**Si3402-A-GM to Si3402-B-GM EVB Modifications  
Version 0.4**

Table 1. Si3402-B-GM EVB modifications versus the Si3402-A-GM EVB

Si3402 (Buck, Non-Isolated) EVB Reference Design - 5V

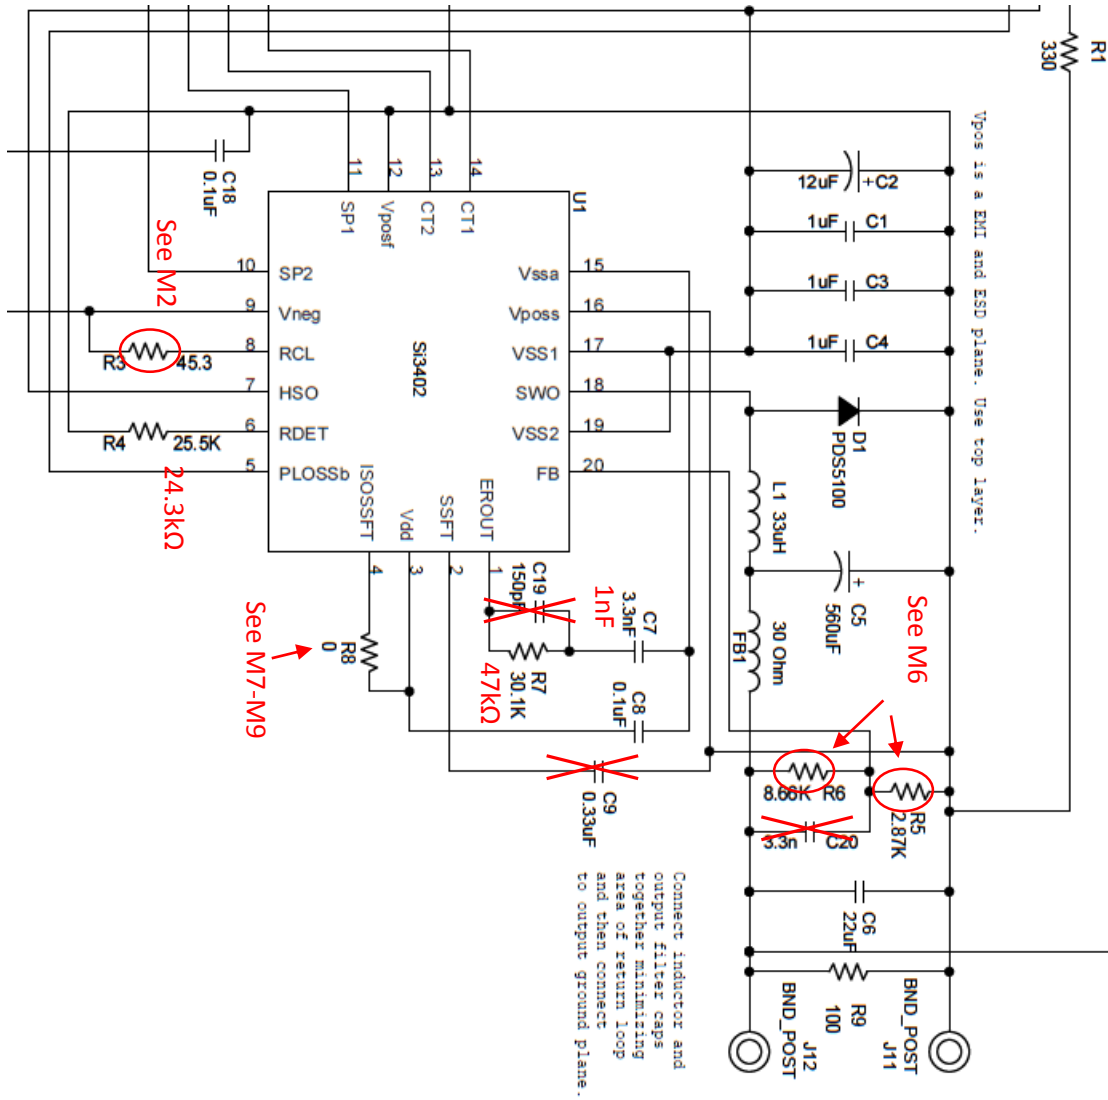
M6	DCDC reference voltage change (Buck case only)	Now 1.35V instead of previous 1.23V. Thus, R5 changes from 2.87kΩ 1% to 3.24kΩ 1%. R6 (1%) is modified according to this table:

Vout Target	R5 kΩ	R6 kΩ	Vref	Vout Measured
		3.3	3.24	4.64	1.35	3.37
		5	3.24	8.66	1.35	4.96
		9	3.24	18.2	1.35	8.93
		12	3.24	25.5	1.35	11.98
M7	BUCK EVB DCDC 3.3V compensation network changes	C19, C20 & C9 are not need—Do not populate them. R8 can be populated with a 0Ω resistor (creating a short between pins 3 and 4) or left unpopulated, since the ISOSSFT function is now internal (see datasheet). C7=1nF, R7=47kΩ ±20%.				
M8	BUCK EVB DCDC 5V compensation network changes	C19, C20, R8 & C9 are not need—Do not populate them. R8 can be populated with a 0Ω resistor (creating a short between pins 3 and 4) or left unpopulated, since the ISOSSFT function is now internal (see datasheet). C7=1nF, R7=47kΩ ±20%.				
M9	BUCK EVB DCDC 12V compensation network changes	C19, C20, R8 & C9 are not need—Do not populate them. R8 can be populated with a 0Ω resistor (creating a short between pins 3 and 4) or left unpopulated, since the ISOSSFT function is now internal (see datasheet). C7=1nF, R7=47kΩ ±20%.
